Agenda Item 3 1175 Old Colony

Continued consideration of a new residence and preliminary landscape plan on a vacant lot.

1175 Old Colony Road

Continued consideration of a new residence on a vacant lot and a conceptual landscape plan.

PROPOSED WEST ELEVATION JUNE 5TH MEETING

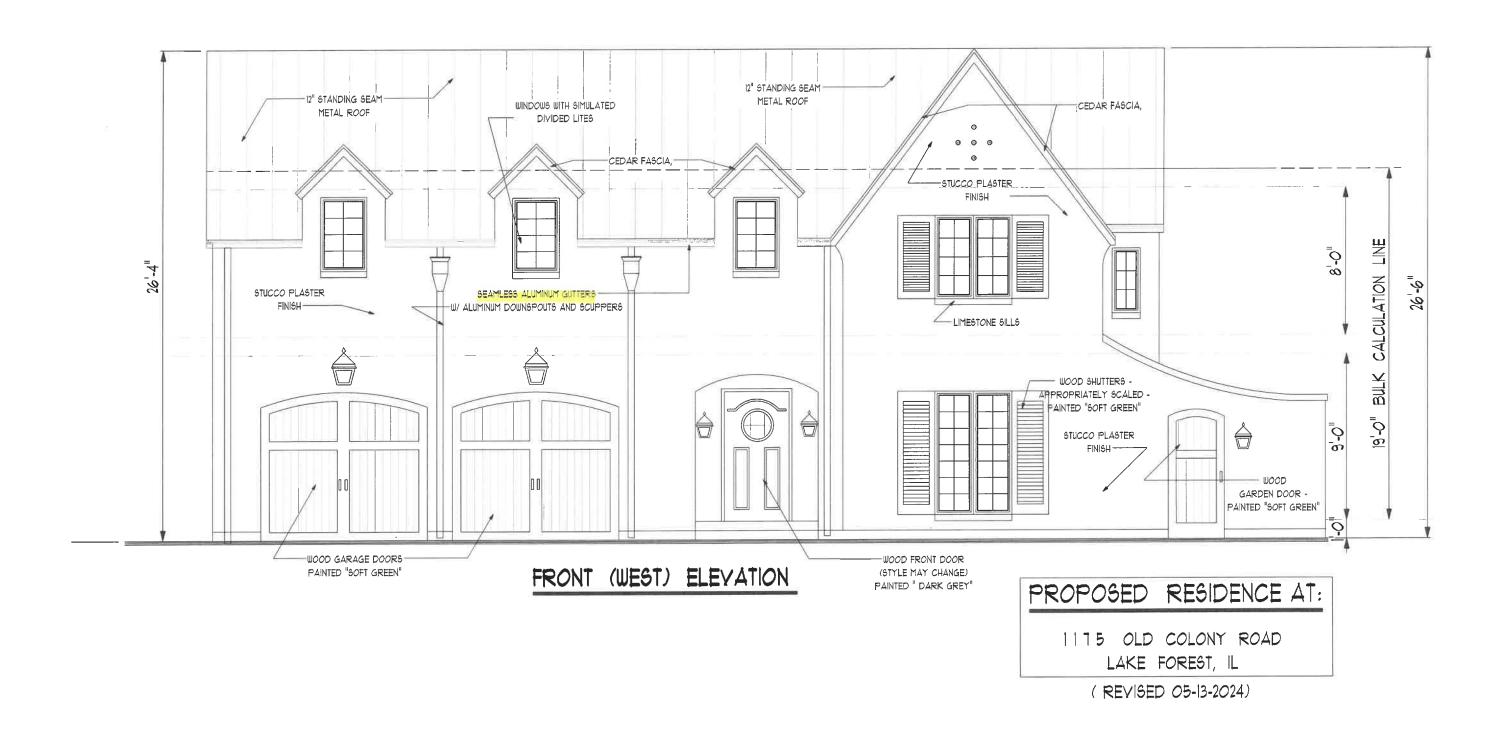
In response to Board direction, each elevation was further detailed. A chimney cap was added and the gutter material was changed from copper on the front façade and aluminum on all other sides to aluminum on all four sides. The balance of solids and voids was refined on the north, south, and east elevations. The north elevation improved with the addition of garage windows and shutters. Shutters were also added to windows on the south elevation. On the south elevation, a door replaced a foyer window and the window at the top of the staircase was enlarged. Windows on the right side of the elevation are now grouped together. On the east elevation, a dormer was added above the rear garage door. Overall, the elevations have benefited from the changes and the changes respond to the Board's direction. Changes are highlighted in the packet.

Staff Recommendation: Consideration shall be given to a masonry chimney to add character and distinction to the home.

<u>I responded</u> by adding detail to each elevation and chimney and removing the window as illustrated in the packet.

PROPOSED FRONT ELEVATION (EAST)

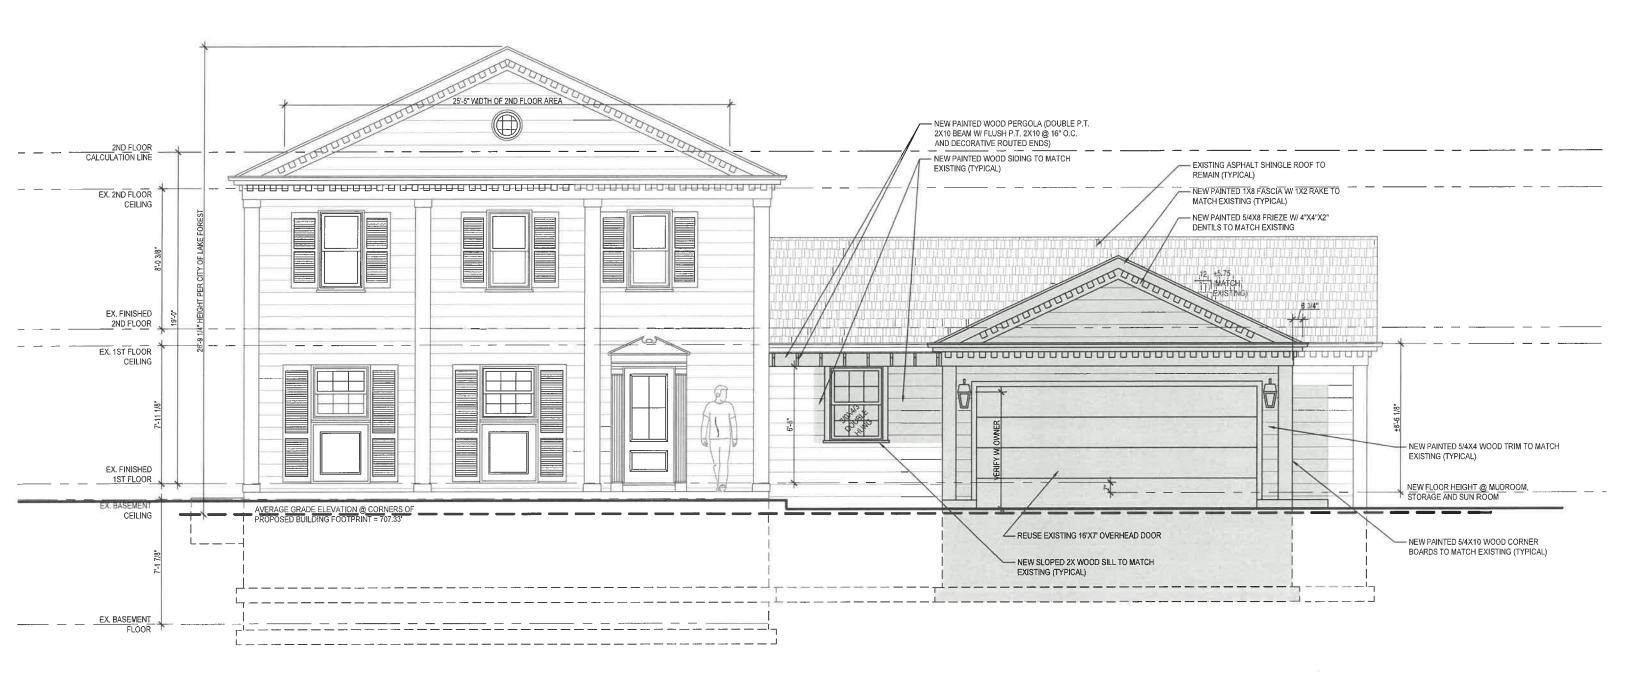
The street facing east elevation shows the new garage and pergola. The garage shape echoes the existing Colonial Revival form with matching detail. An additional window on the left of the garage replaces an existing, larger window.

PROPOSED SIDE ELEVATION (NORTH)

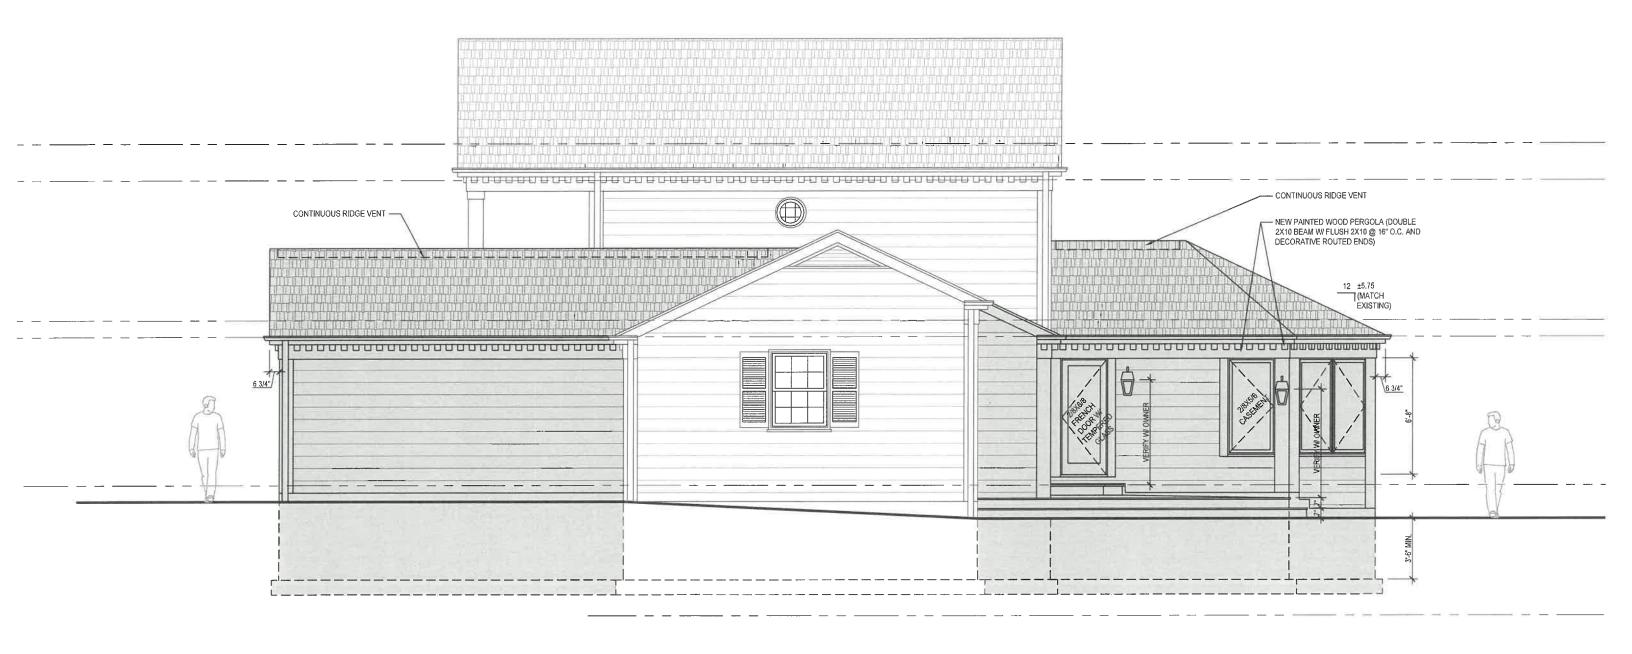
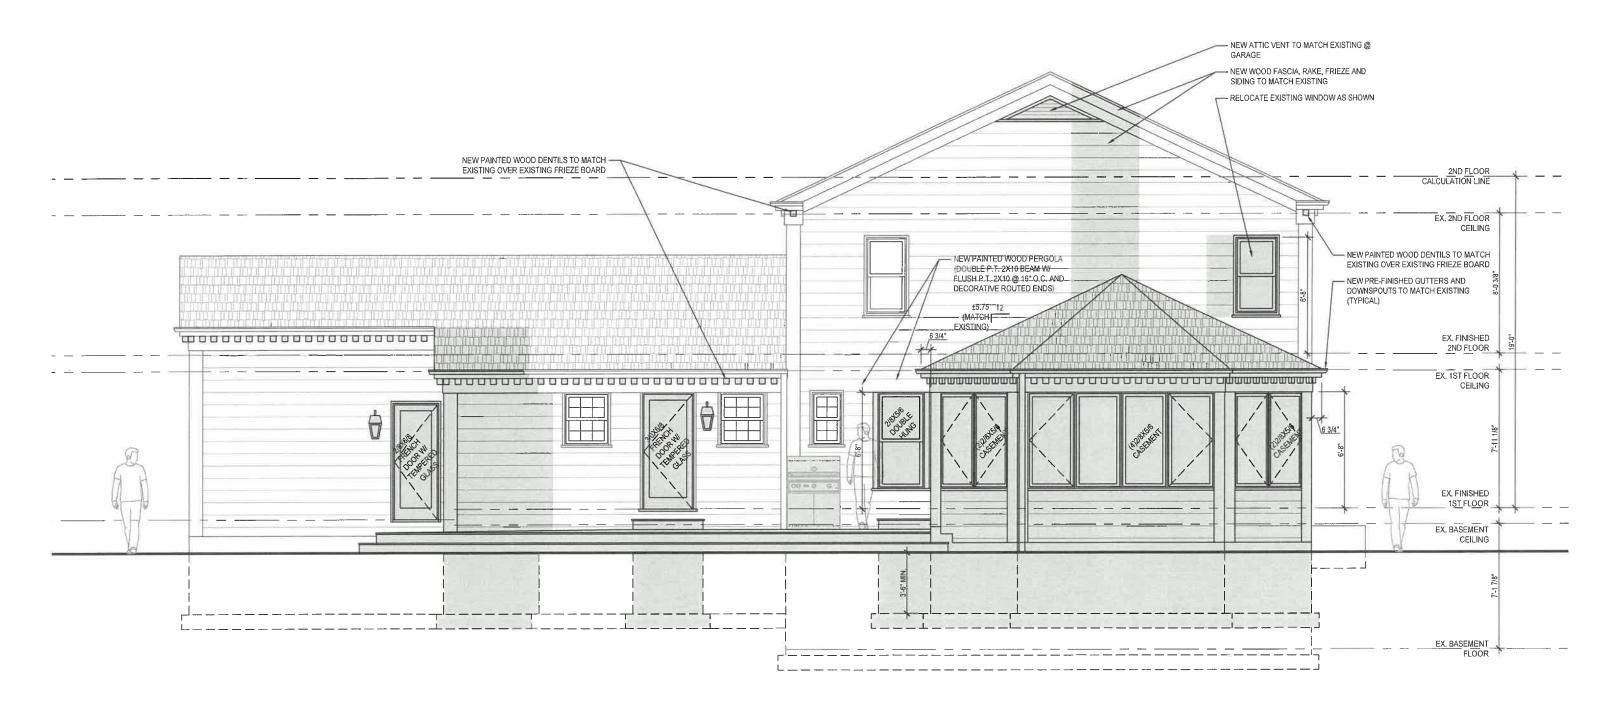
- 1. Conduct further study of the north and west elevations with attention to improving the balance between solids and voids.
- 2. Landscaping negatively impacted by construction shall be replaced.
- 3. Consider the use of a square shape, rather than an octagonal shape, for the dining room addition.
- 4. Conduct further study of the proposed dining room windows to better match the existing structure.
- 5. All modifications to the plans including those detailed above and any others made in response to Board direction or as the result of final design development, shall be clearly called out on the plan
